October 8, 2020

18-027(a).R01

Re: Slope Assessment
Saugeen Cedar Heights West
Hanover, Ontario

DRAWING TITLE:
PLAN AND PROFILE VIEW SHOWING PHOTOGRAPH AND SLOPE CROSS-SECTION LOCATIONS

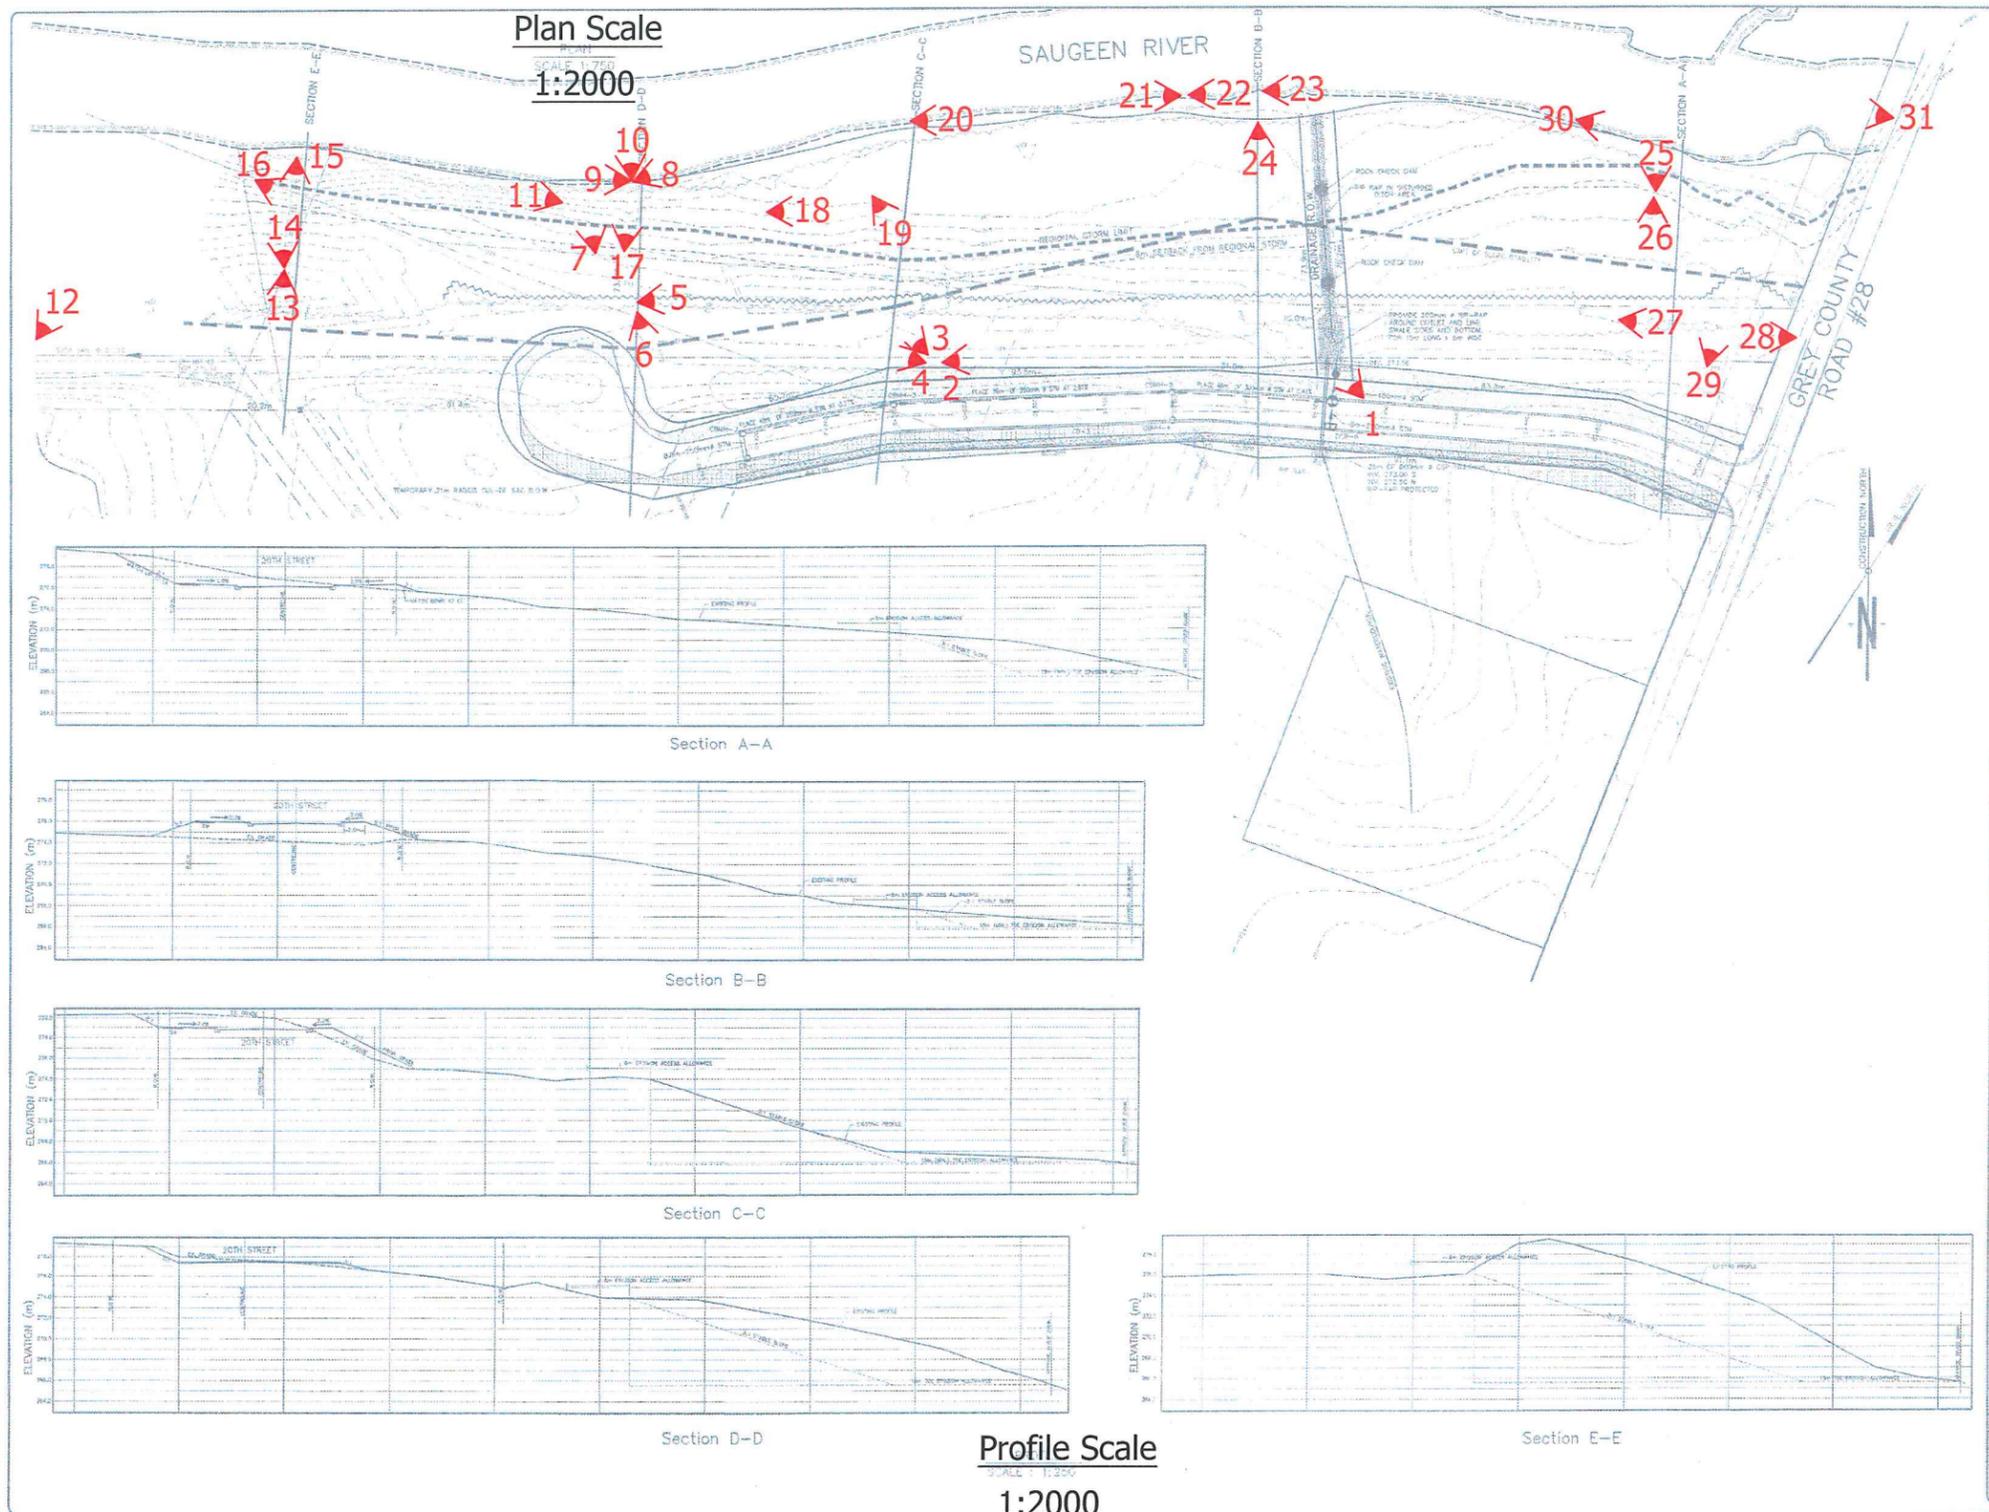
CMT Inc. personnel conducted a site visit on September 29, 2020 which was comprised of examining the site to visually verify that the existing slope sections are generally consistent with the site plan completed 2007. Photographs were taken during the site visit and the location of the photographs relative to the cross-sections are shown on Drawing 2.

CVD reported a stable slope angle of 3H:1V and determined the stable slope allowance by superimposing a 3H:1V stable slope line at the southern extent of the 15.0 m toe erosion. The location where the superimposed 3H:1V stable slope line intersected the existing topography was determined to be the southern extent of the stable slope allowance. Therefore, the existing stable slope allowance is within the MNRF technical standards. CMT Inc. believes that the stable slope allowance may be able to be reduced from what was reported by CVD by increasing the angle of the stable slope line through slope stability modeling for each cross-section and further geotechnical testing, if required.

In conclusion, the existing development setbacks from the 2007 report from CVD remain acceptable under the MNRF technical standards and SVCA Environmental Planning and Regulation Policies Manual. Based on a visual inspection by CMT Inc. personnel, the topography at the cross-section locations of the site appears to not have significantly changed from 2007 to today. If the owner wishes to move the development setback closer to the river, this may be possible from a geotechnical perspective by reducing any combination of the toe erosion allowance, stable slope allowance, and erosion access allowance. Further geotechnical testing and/or analysis will be required to modify setbacks from what was previously completed by CVD. CMT Engineering Inc. would be pleased to provide a proposal to provide this work. It should be noted that the erosion hazard (slope stability) is not the only technical factor limiting development closer to the Saugeen River. Other technical factors such as setbacks from flood lines should also be considered.
